Amendments to the Drawings

Marked up drawing
Serial No. 09/709,237

Fig. 5

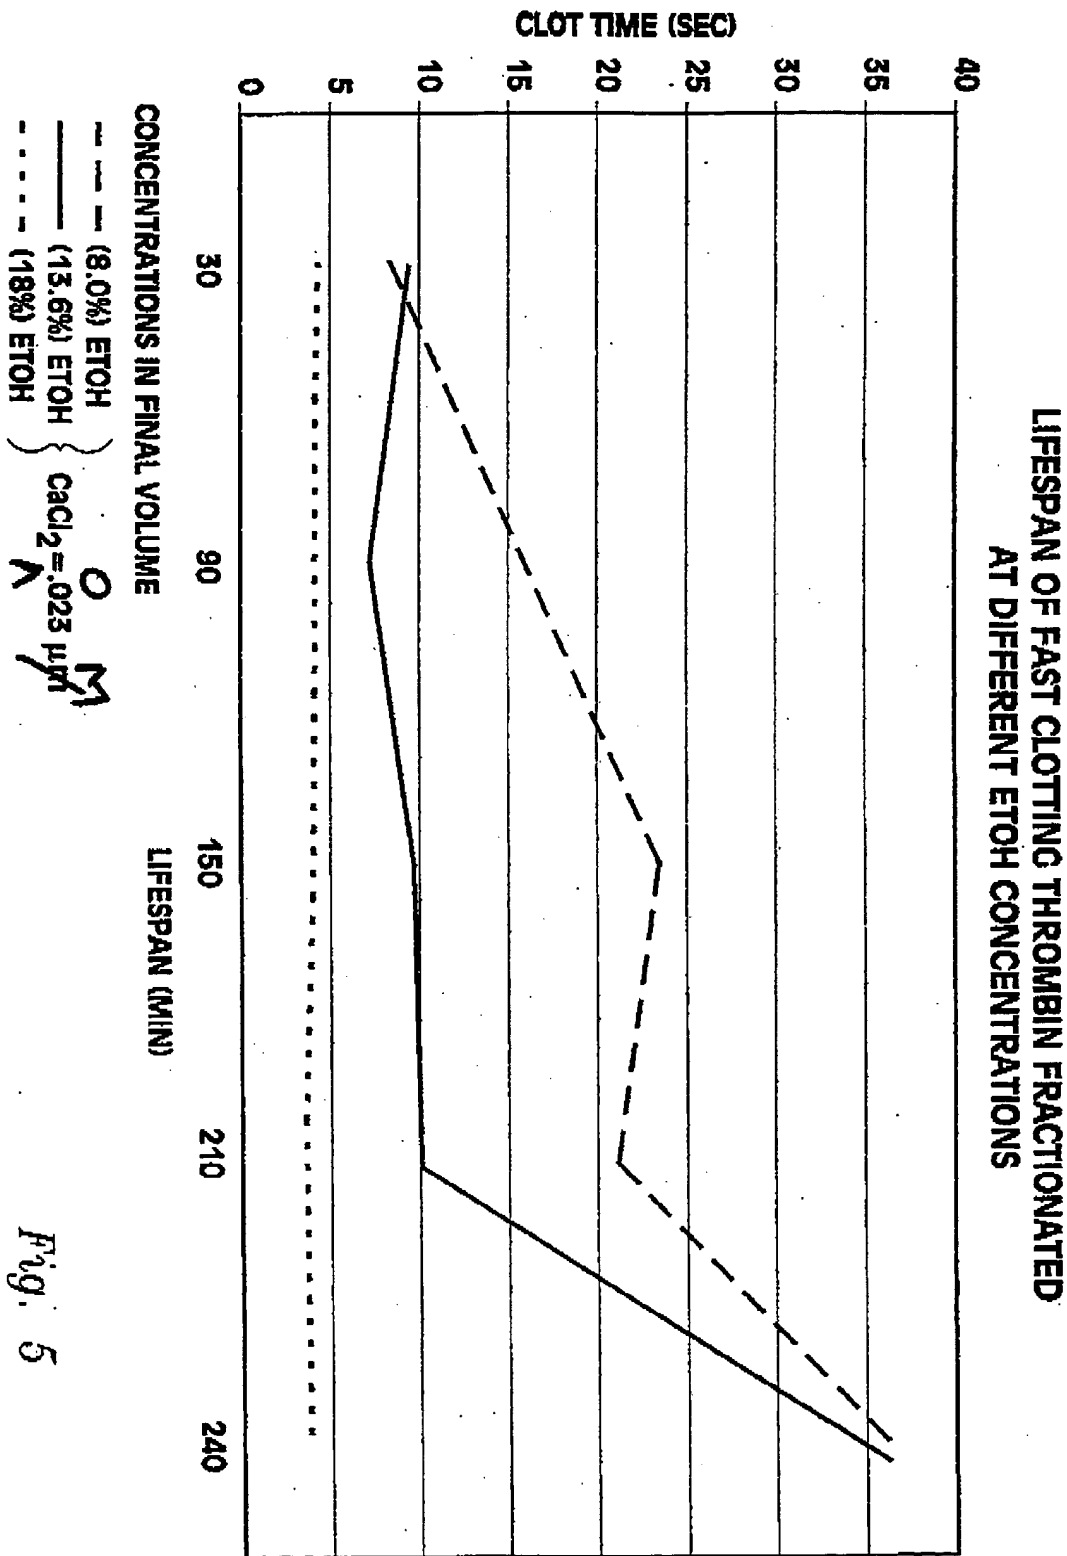
Figs 5 and 6 have been corrected in response to the Examiner's objections, to show the proper abbreviation for micromolar. Figs. 5 and 6 now read " μM " instead of "mM."

Applicants have also amended Figs. 5, 6, 7, 8, 9, 10, and 11 to refer to "0.023", "0.011", and "0.045" instead of "023", ".011", and ".045", respectively to add a "0" in the ones column for clarity and ease of reading.

The Examiner has objected to Figs. 5 and 6 on the grounds that they refer to the concentration of calcium chloride in units of " μm " which is an incorrect abbreviation for micromolar (μM). (Office Action, page 3, paragraph 6). Applicants appreciate the Examiner's notation of this error. Applicants have corrected Figs. 5 and 6 to read " μM "

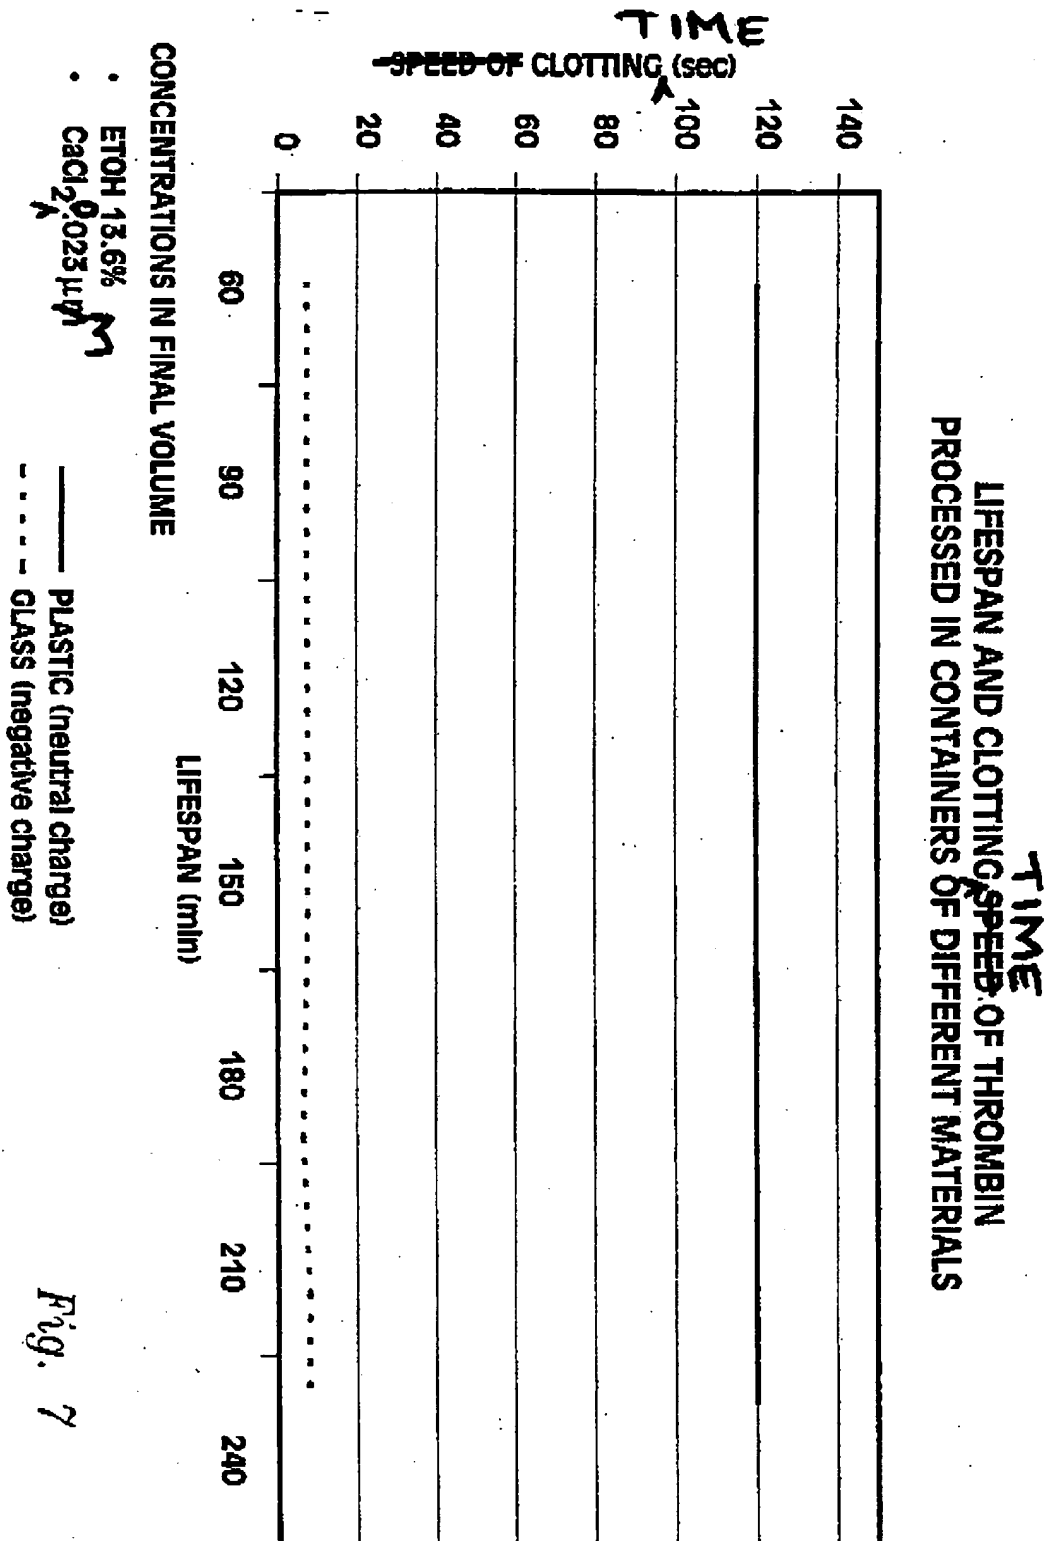
In addition, applicants have corrected Figs. 7, 8, 9, 10, & 11, which also contain the same error. These figures now read " μM " instead of "mM."

Applicants have amended the title of Fig. 7 to change "clotting speed" to "clotting time." Fig. 12 has also been amended to add a label to the Y axis of "Clotting Time (Sec)", which was inadvertently omitted in the submission of formal drawings.

In addition, applicants have corrected the title of Fig. 7 to change "clotting speed" to "clotting time" and Fig. 12 to add a label to the Y axis of "Clotting Time (Sec)". The omission of the label on the Y axis of Fig. 12 was an inadvertent omission in the submission of formal drawings, as Fig. 12 as originally submitted included this label.
